## TULSA METROPOLITAN AREA PLANNING COMMISSION

For Meeting No. 2568
December 16, 2009, 1:30 PM
175 East 2<sup>nd</sup> Street, 2<sup>nd</sup> Level, One Technology Center **Tulsa City Council Chambers**

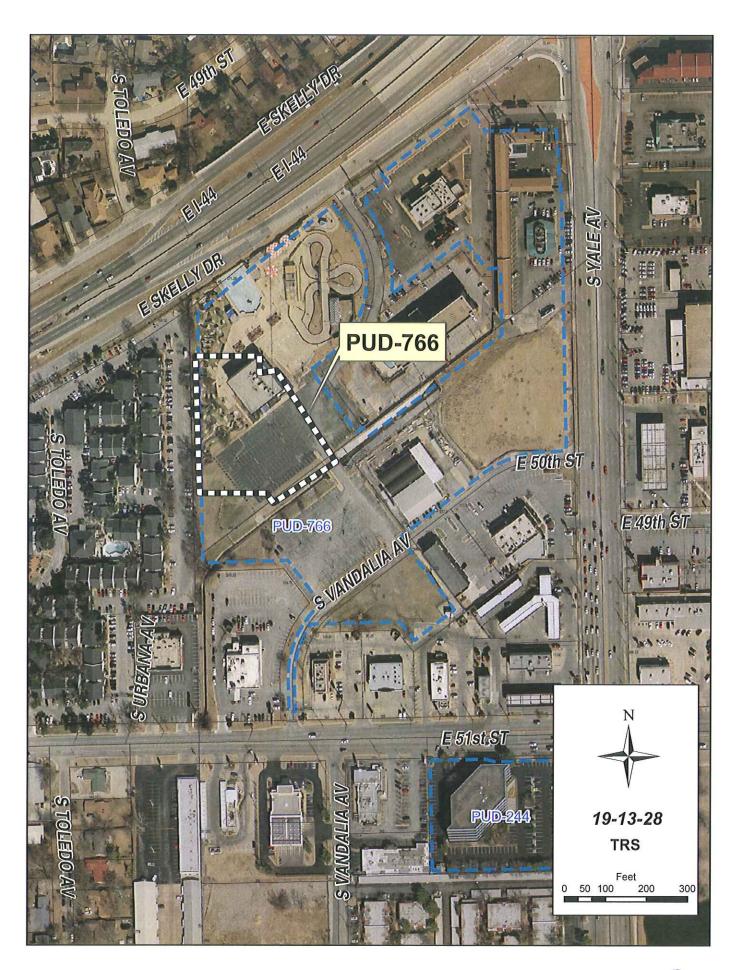
The applicant is requesting a minor amendment to reduce the required rear setback from 25' to 20' on Lot 15, Block 6 of the Wind River residential single-family subdivision. The request is for a small portion of the house only as depicted on the attached exhibit A and would not relax the setback for the entire lot.

Lot 15, Block 6 is a five sided lot with utility easement along all lot lines somewhat limiting the buildable area of the lot. Also, the lot line along which the reduction is being sought abuts directly to South Toledo Avenue. The small encroachment into the required setback should not have any affect on another single-family property.

Therefore, staff recommends **APPROVAL** of minor amendment PUD-686-6 reducing the rear setback on Lot 15, Block 6 – Wind River from 25' to 20' for the area highlighted on the attached exhibit only.

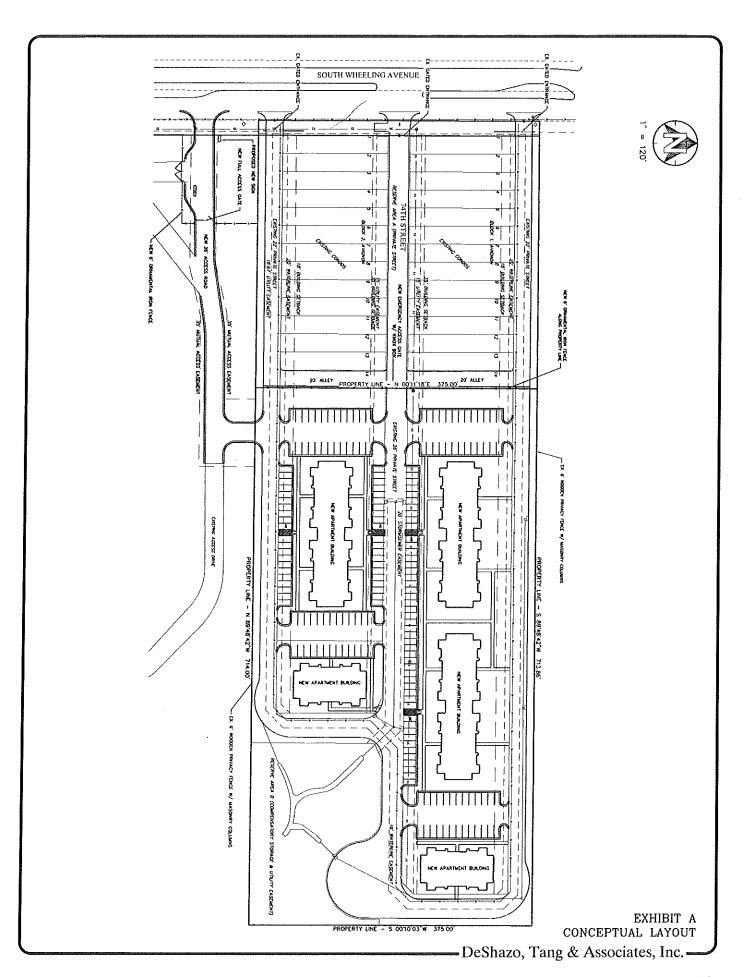
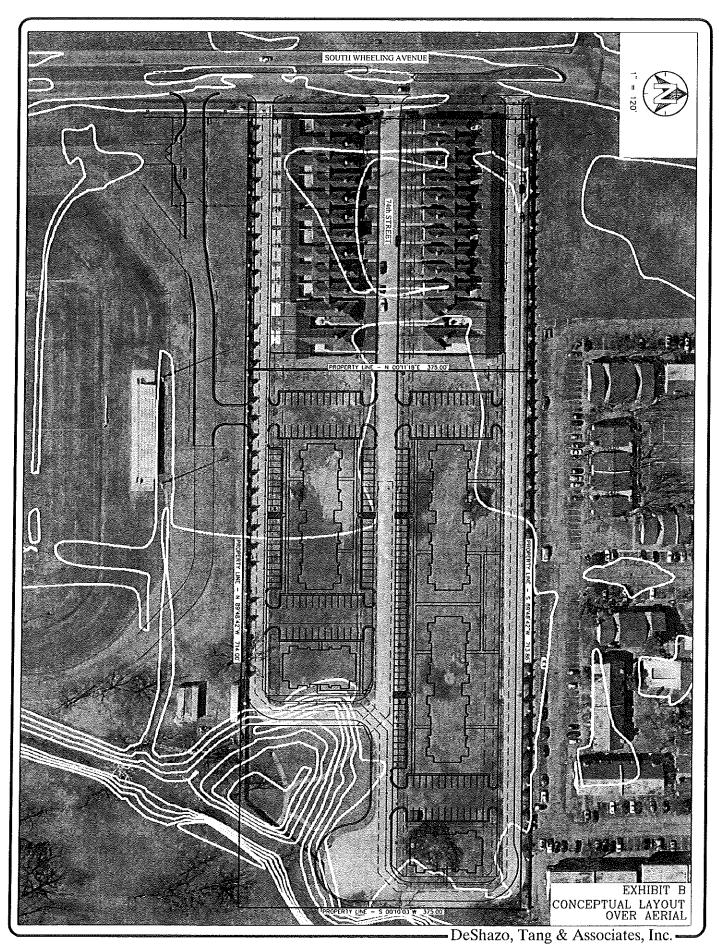
Fire: Provide 28' radius on Lots 13 of Blocks 1 & 2 to allow a fire truck to make the turn.

Provide Aerial Fire Apparatus Access Roads per Section D105 of the International Fire Code.

<u>Wastewater:</u> The existing sanitary sewer main must be brought up to City of Tulsa Standards before any sewer connections can be permitted.
